RE: Summerfield Park Subdivision
Town of Whitchurch - Stouffville
Proposed Storm Sewer Crossing
FDS WO 88-11004
Hwy. 47, District 6, Toronto

As requested, we have reviewed the PMG Consulting Engineers proposal to install a storm sewer across Hwy. 47.

Re: Summerfield Park - Town of Whitchurch, Storm Sewer Crossing - Encroachment Permit No. 16819

PLAN No B-8520-9

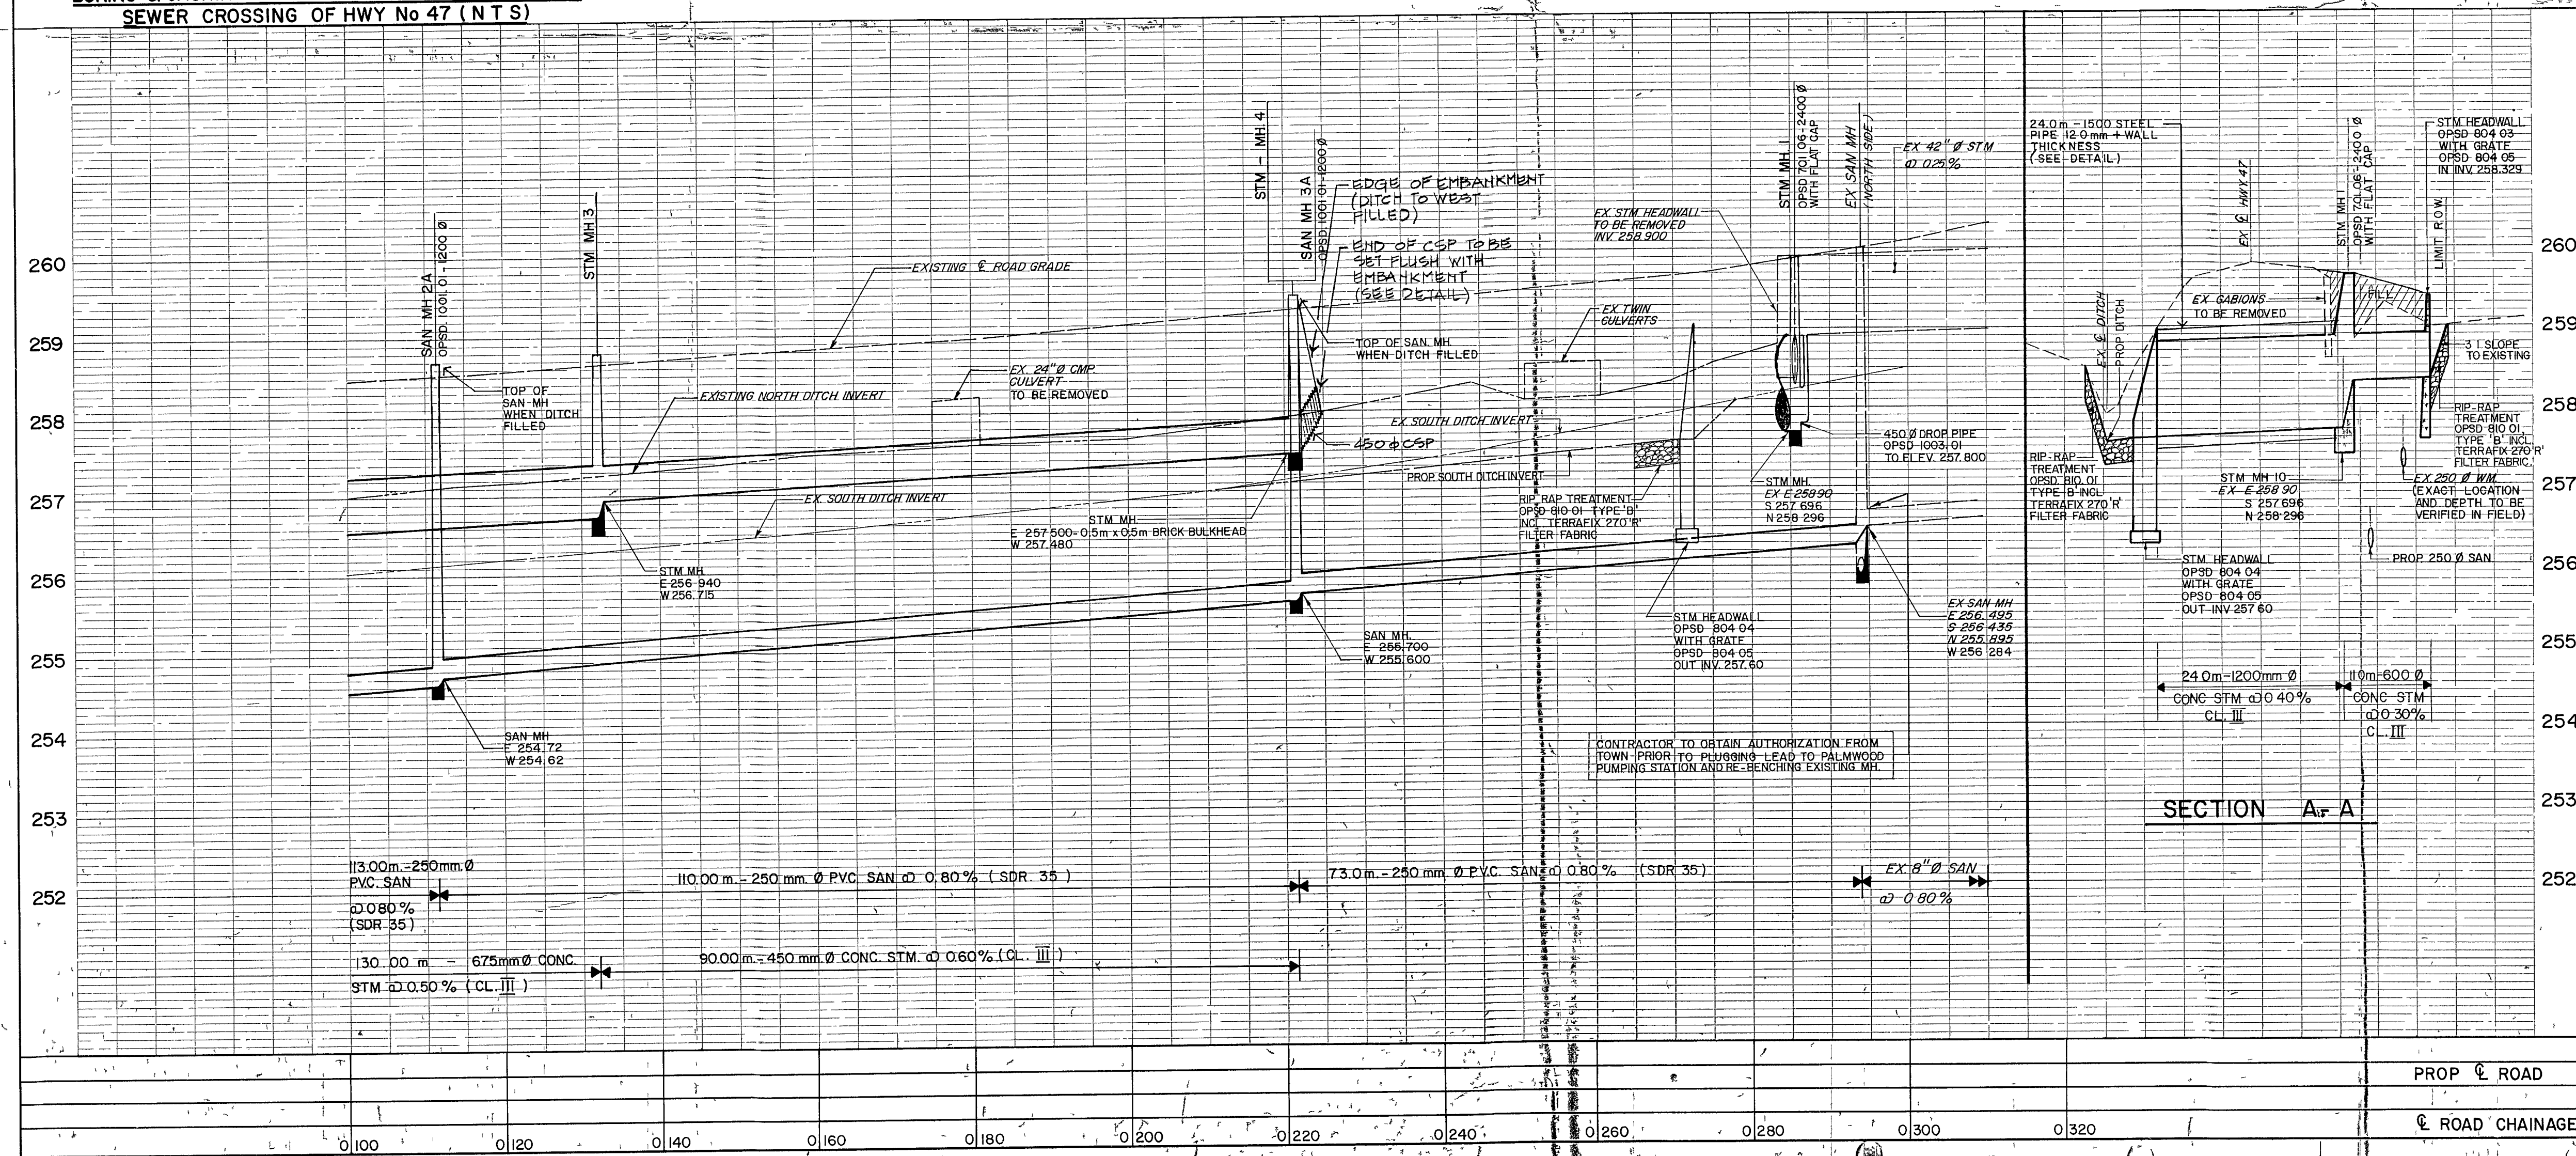
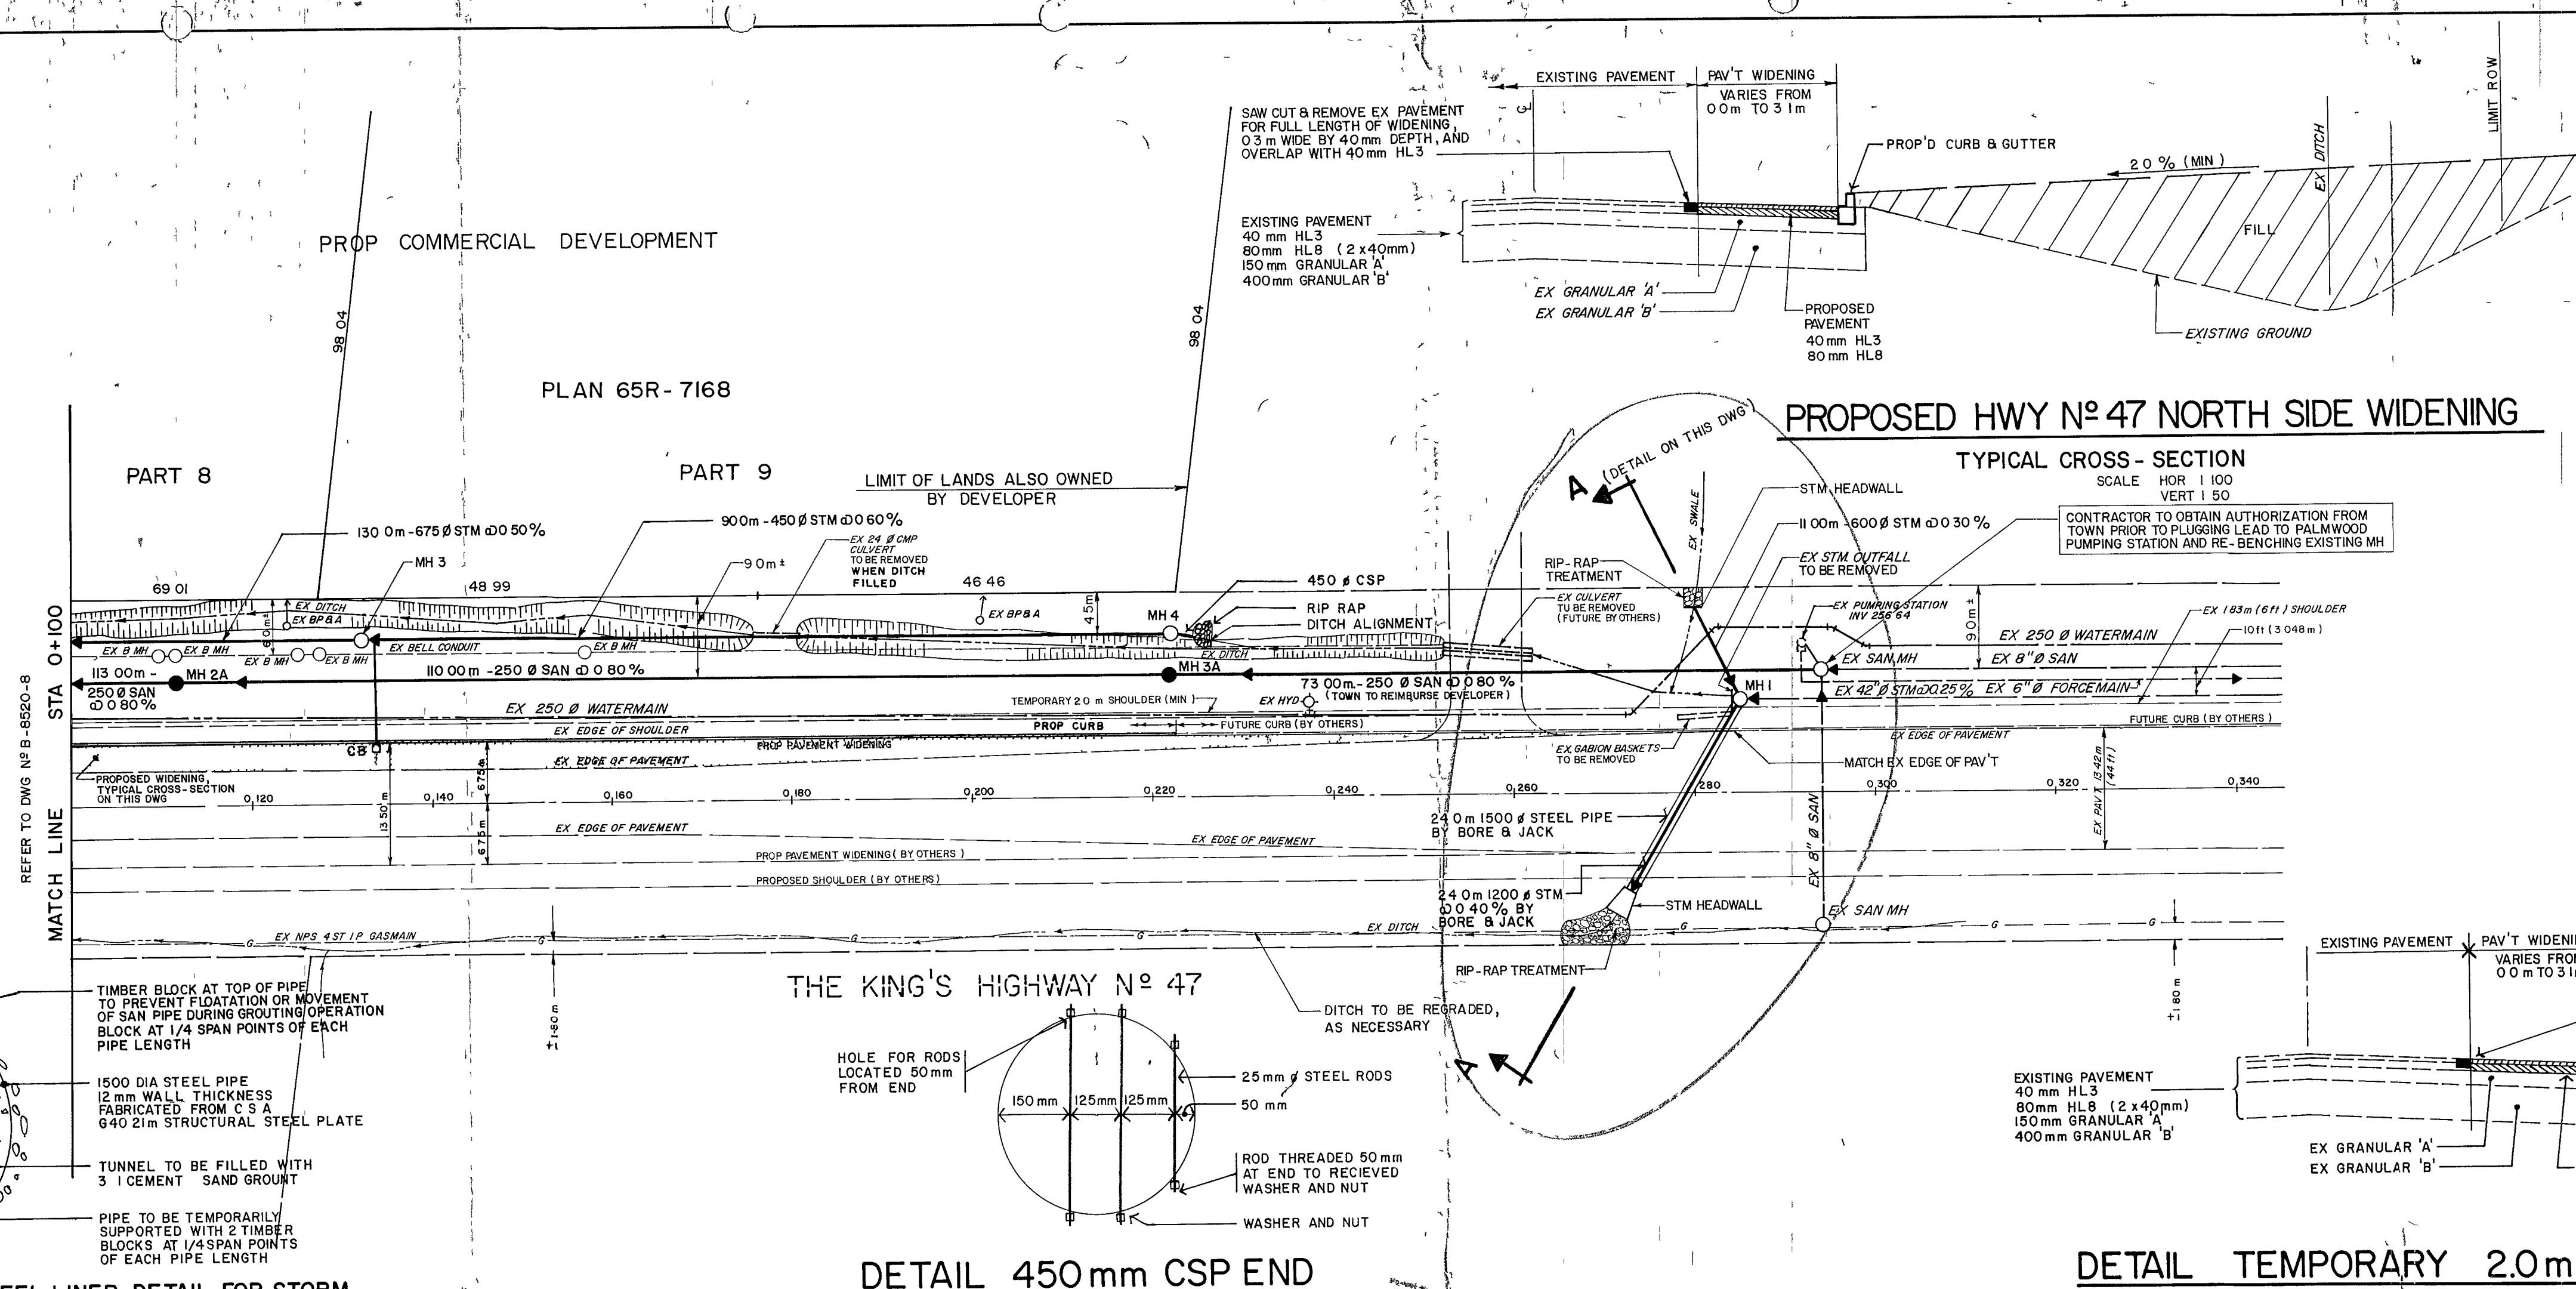
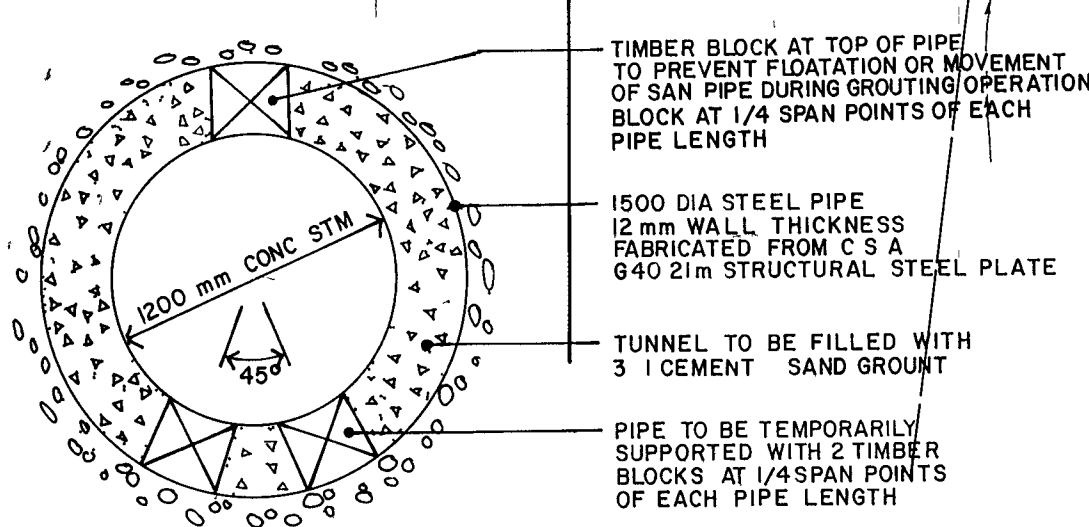
We have received several drawings and have assumed that you refer to the 24 m long, 1200 mm diameter pipe detailed in Section A-A on PMG Dwg. B-8520-9 dated January, 1987.

Based on our review, it appears that the 1.2 m sewer has a minimum cover of 0.8 m above the crown. In order to develop adequate arching a minimum cover of 1.5 X to 2 X diameter is usually required for tunnelling operations. If the sewer can not be redesigned to provide adequate cover, consideration should be given to open excavation methods. However, settlement within the backfill material for the cut will occur. These settlements can be minimized by using granular backfill and ensuring proper compaction.

Regardless of which installation method is adopted, the type of subsurface material and the elevation of the groundwater are important considerations for design and construction.
